Doc. No. BECO/ESR-1
SEPTEMBER 1984
REV. 1

Detailed Control Room Design Review

Executive Summary Report

Pilgrim Station

FIGURE 3-23.
GLAND SEAL STEAM AND
GLAND SEAL STEAM EXHAUSTERS

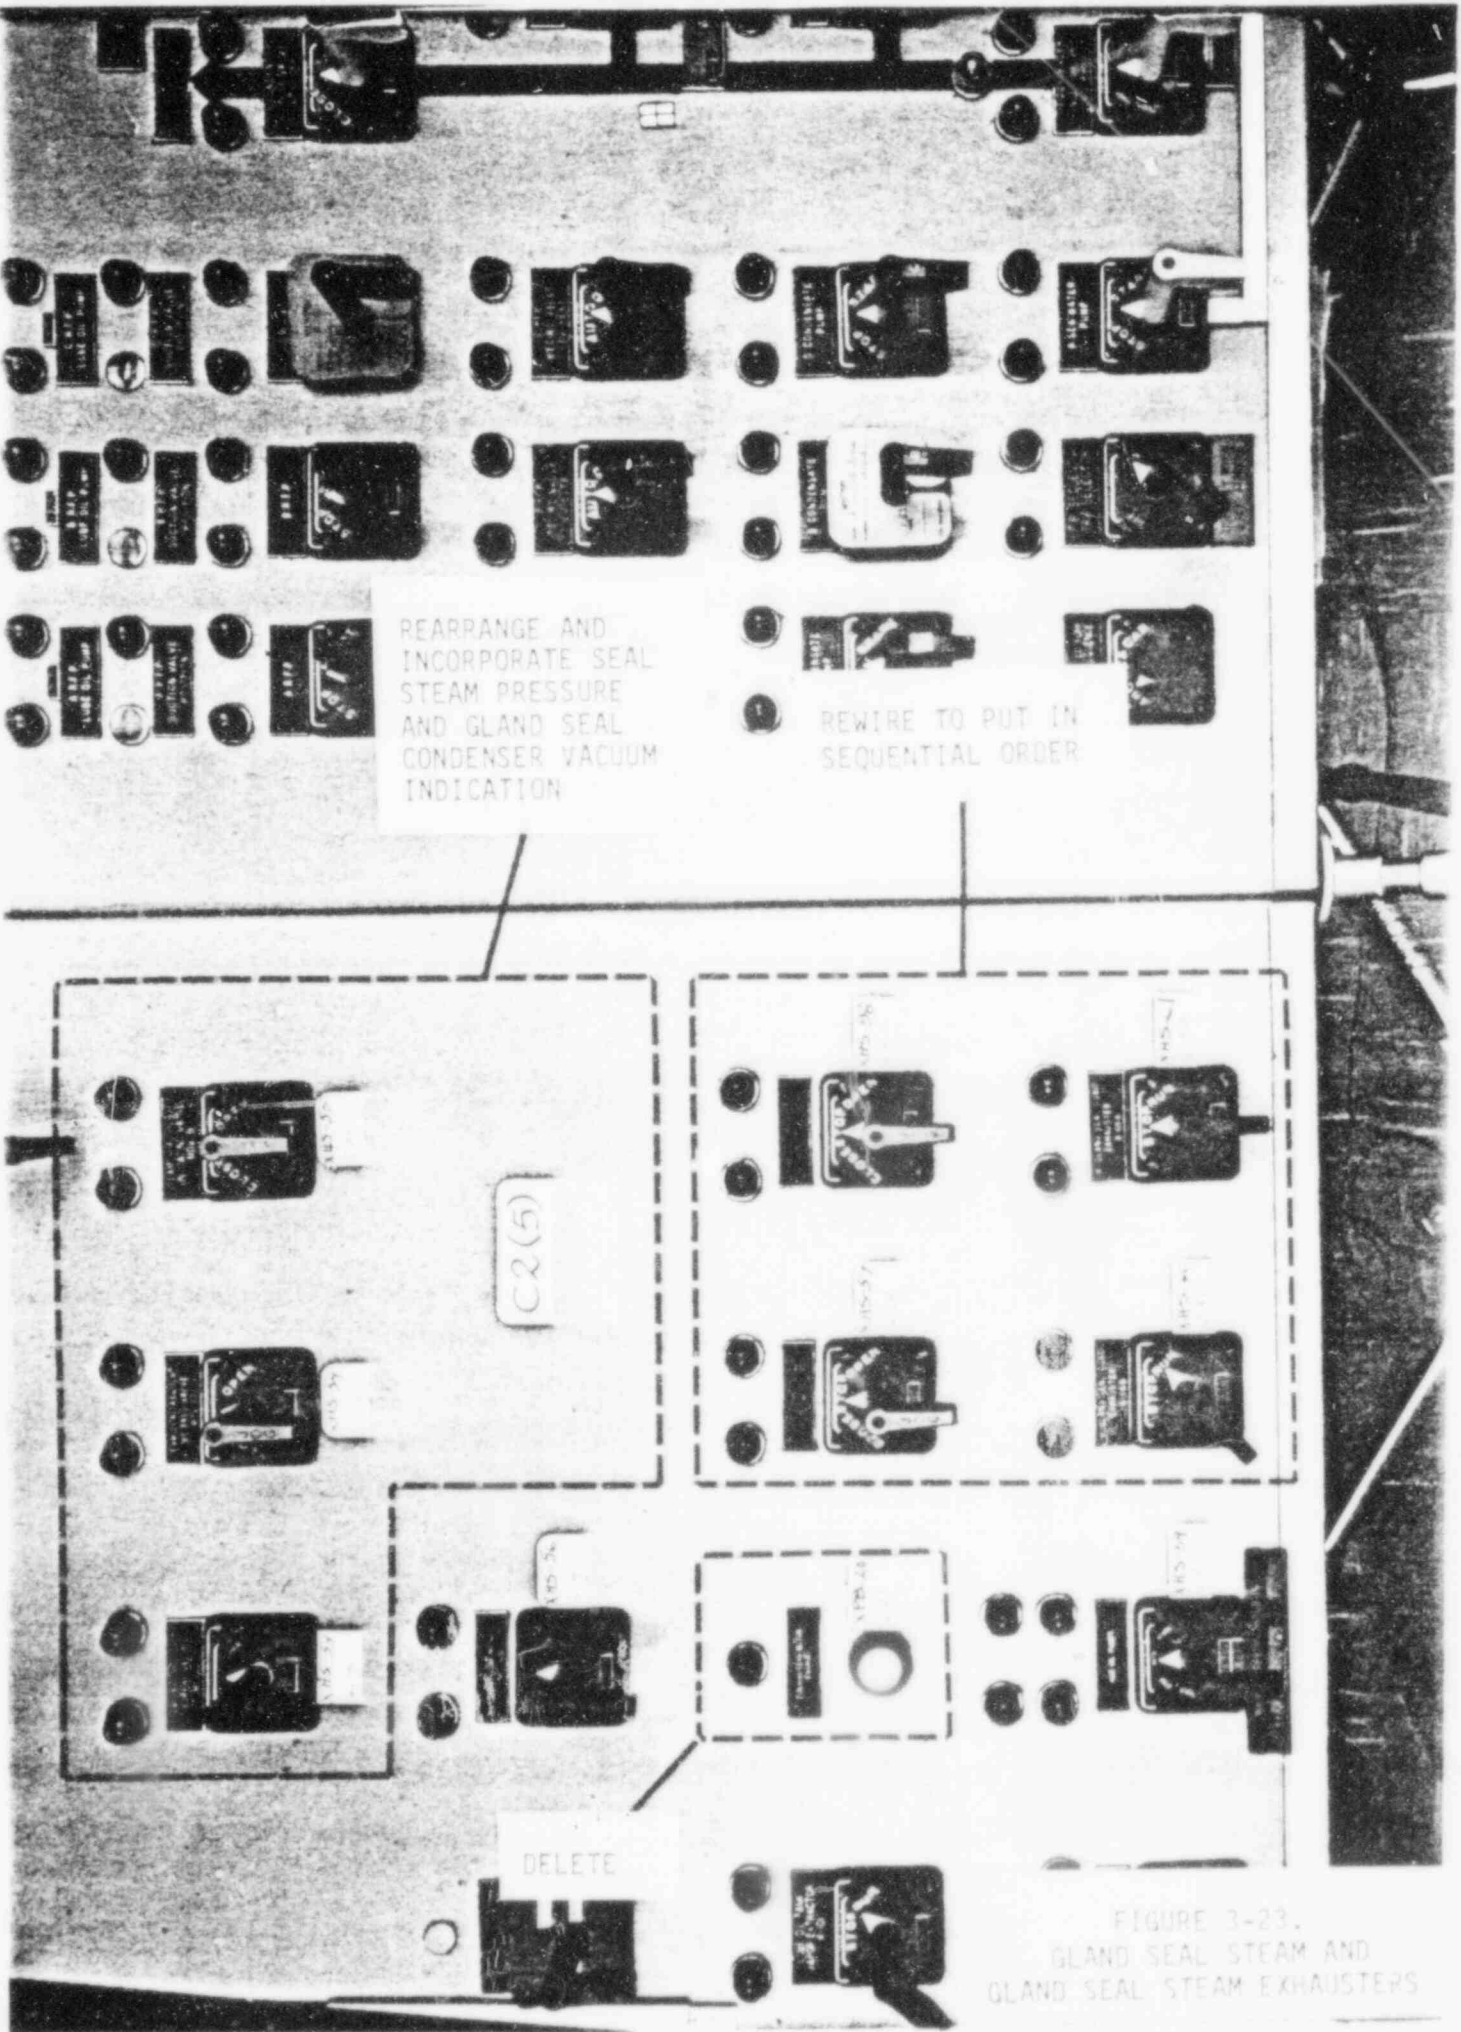
Figure 3-23 shows the gland seal condenser exhausters associated with HED 8B103.5 as they are presently arranged. HED 8B103.5 requires that they be rearranged to be pumps A and B on top, and pumps C and D on the bottom.

Figure 3-23 shows the gland seal system components as they are at present. HED 9B109.5 requires that the gland steam seal header pressure meter and gland seal condenser pressure, from Figure 3-17, be integrated with the gland seal system components shown in Figure 3-23 causing a system rearrangement.

DELETE

FIGURE 3-29.
DIESEL GENERATOR "A" METERING

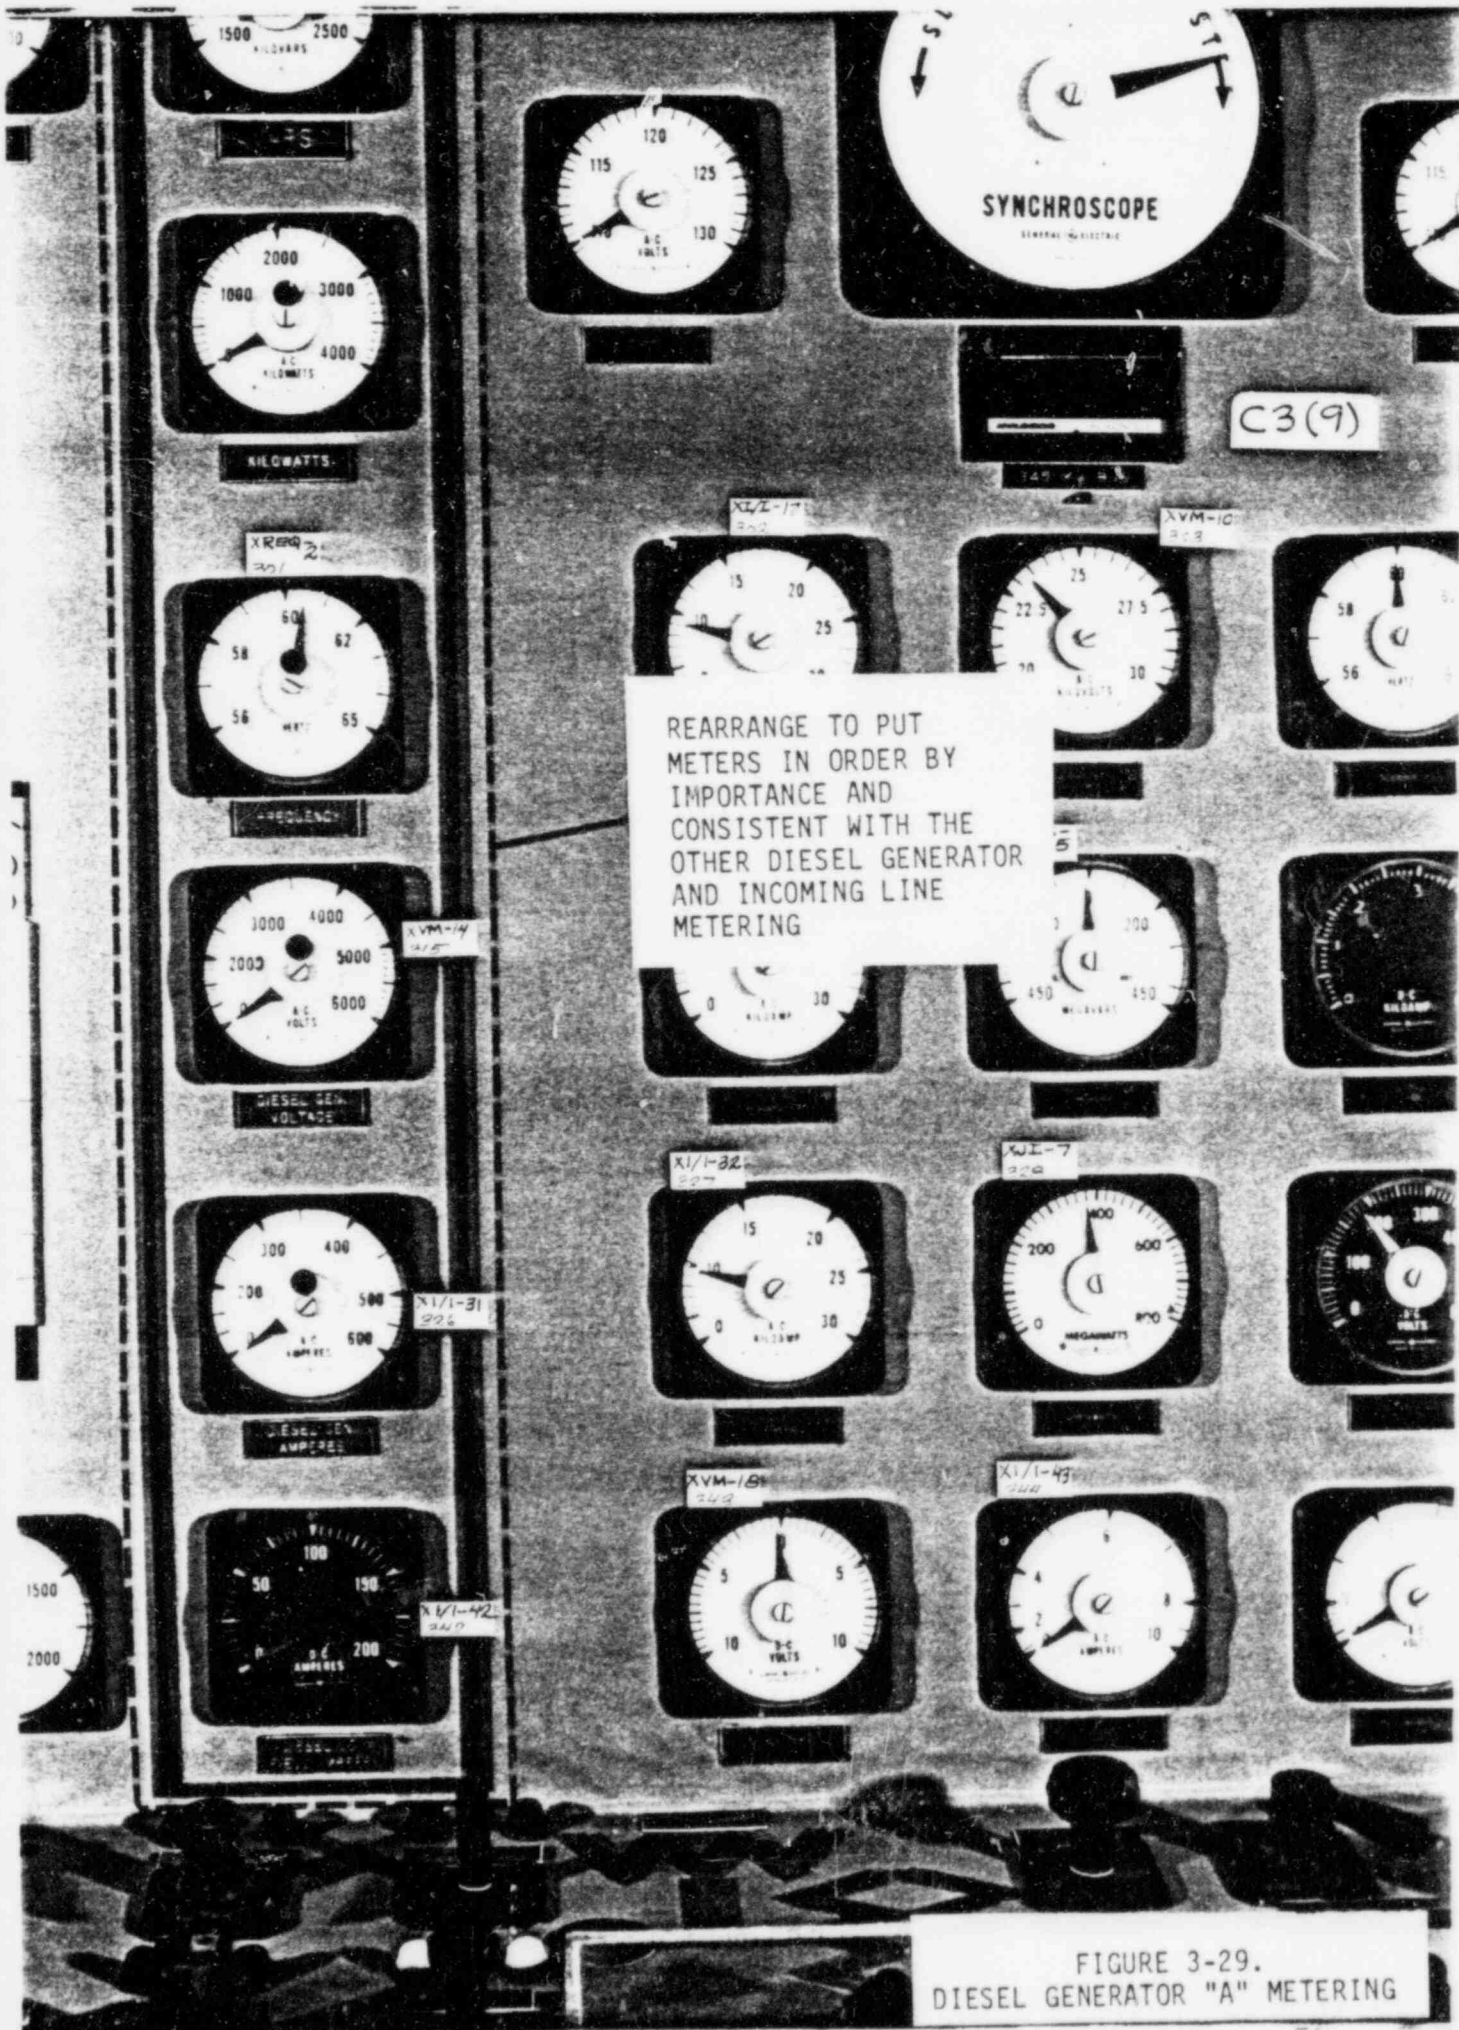
REARRANGE TO PUT METERS IN ORDER BY IMPORTANCE AND CONSISTENT WITH THE OTHER DIESEL GENERATOR AND INCOMING LINE METERING

FIGURE 3-32. DIESEL GENERATOR "A", STARTUP TRANSFORMER AND 4160V BUS 1-A2

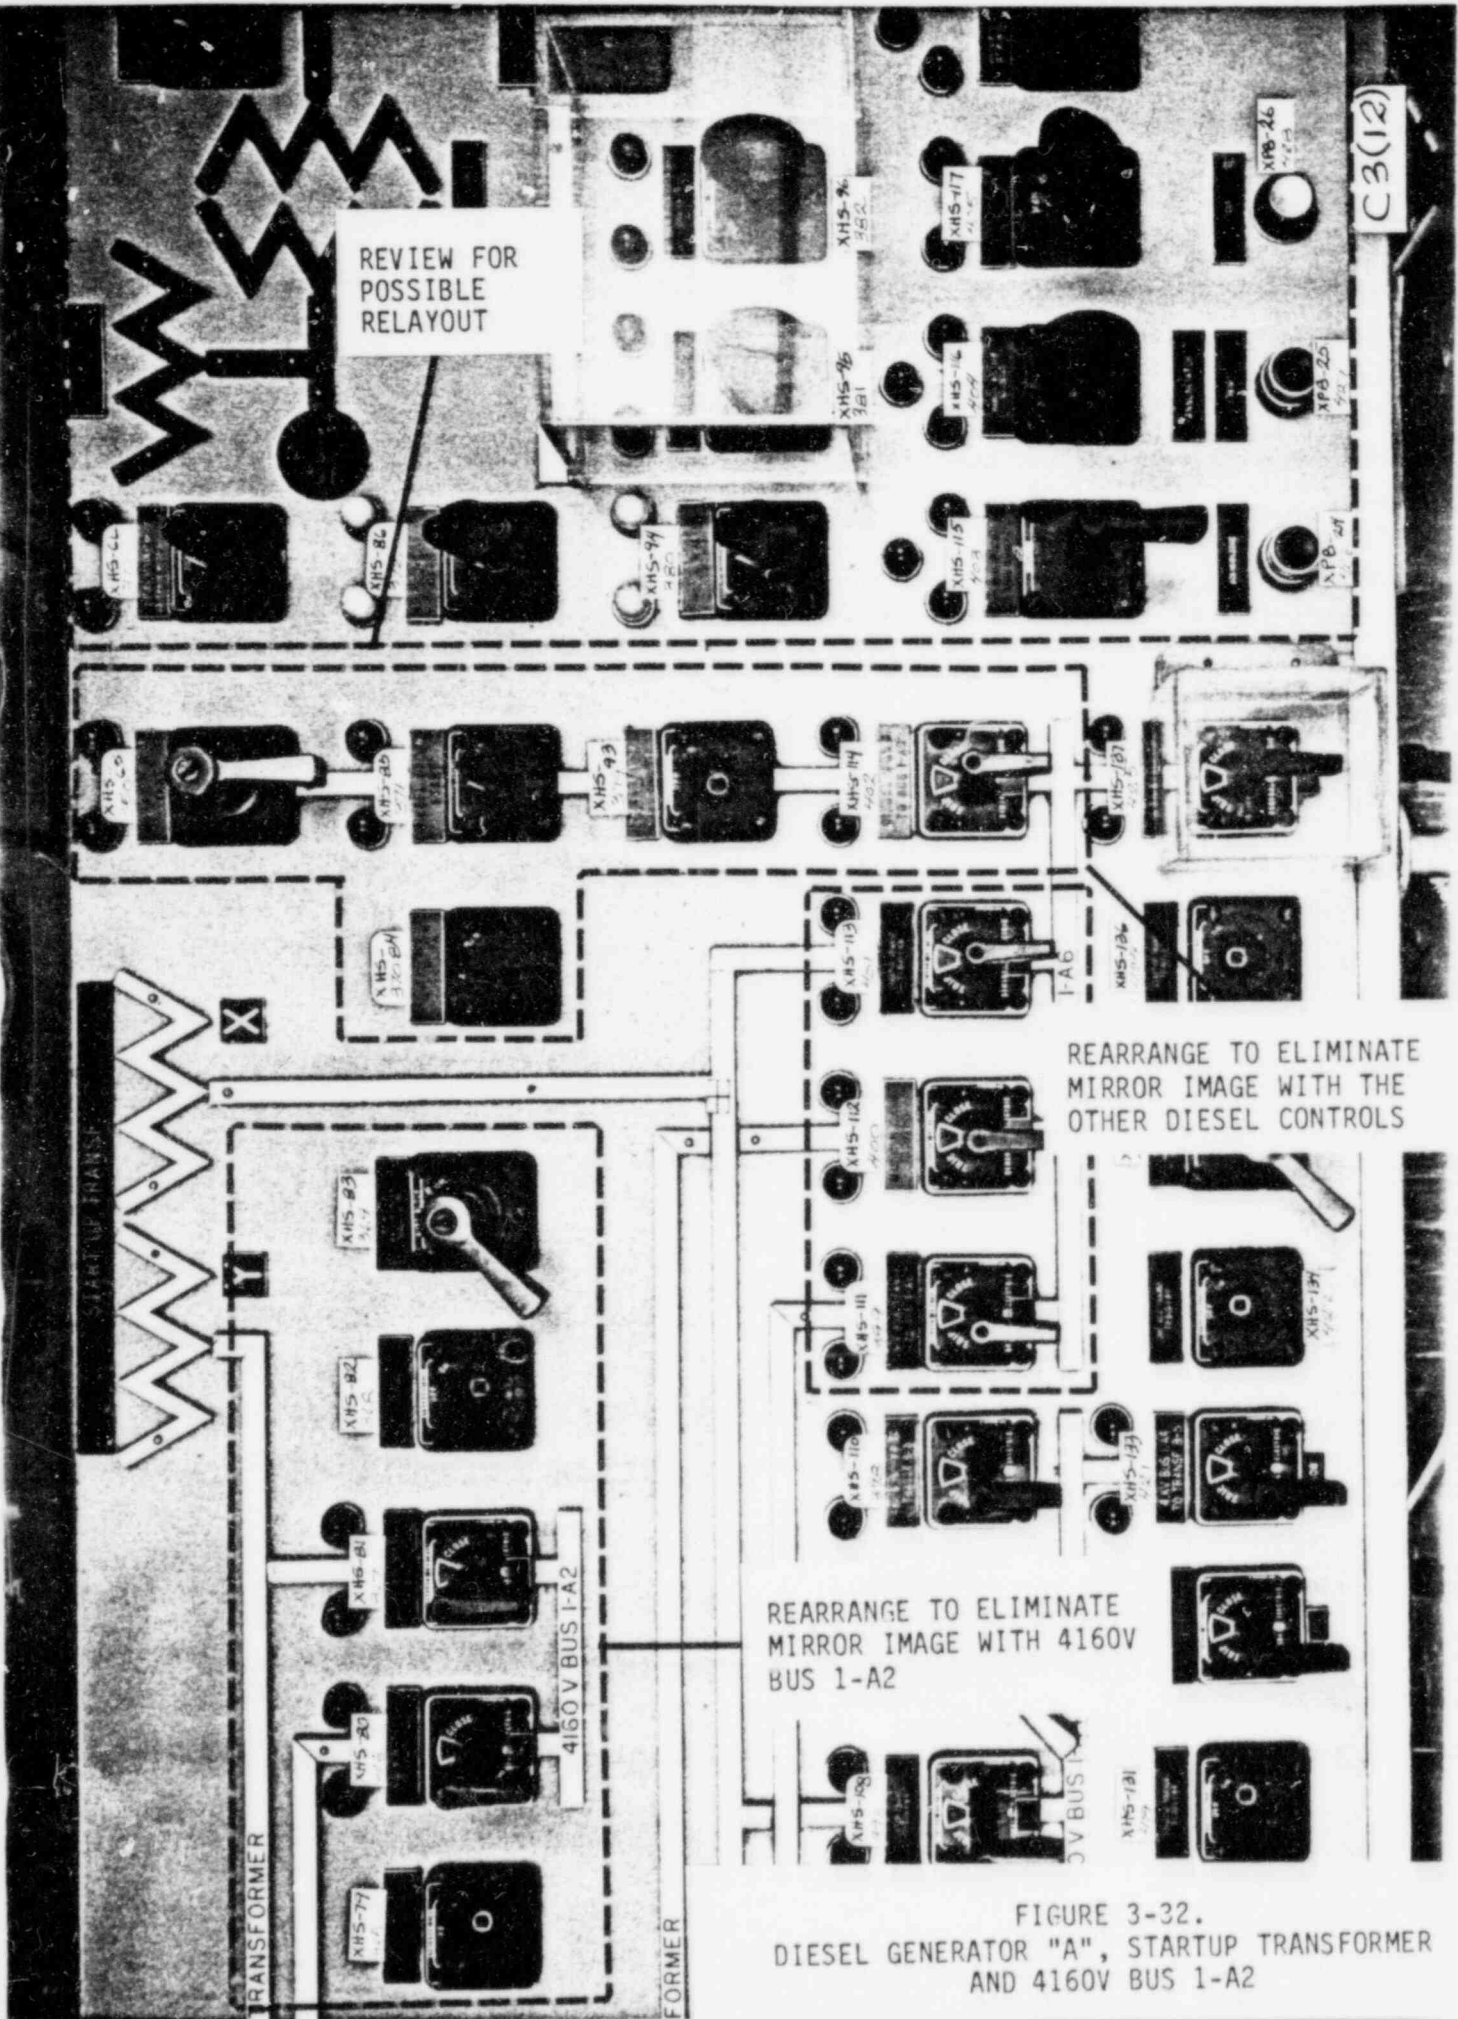
Figure 3-32 shows the UAT and Start-Up Transformer 1-A2 controls associated with HED 8B097.5 as they are at present. Rearrangement of the controls for 4160V Bus. 1-A2 will be required to overcome the mirror image with 4160V Bus 1-A1.

REVIEW FOR POSSIBLE RELAYOUT

REARRANGE TO ELIMINATE MIRROR IMAGE WITH THE OTHER DIESEL CONTROLS

FIGURE 3-33.
GENERATOR OUTPUT BREAKERS

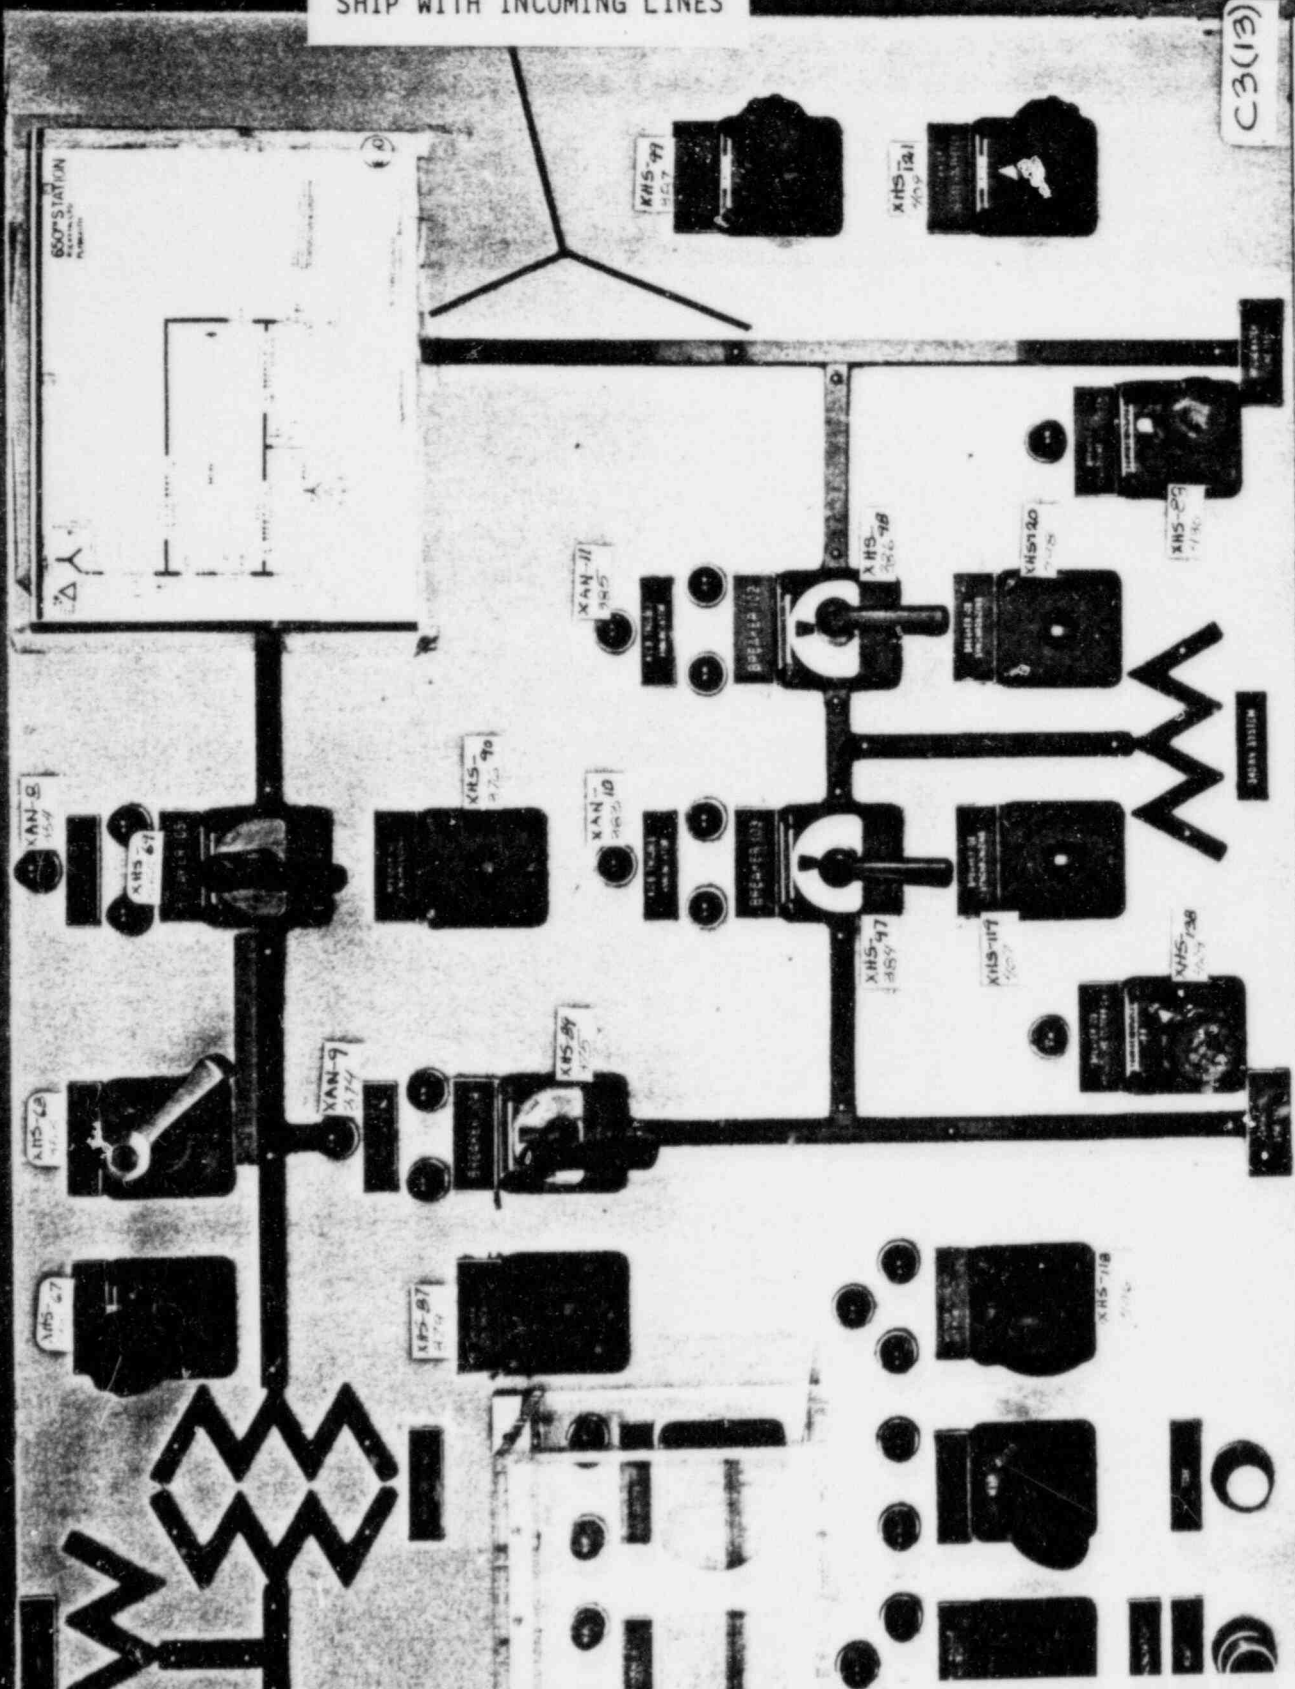
Figure 3-33 shows the generator output breakers and generator controls. These are being considered for rearrangement to clarify the interrelationship between the generator controls and incoming lines.

REVIEW FOR POSSIBLE
REARRANGEMENTS TO
CLARIFY INTERRELATION-
SHIP WITH INCOMING LINES
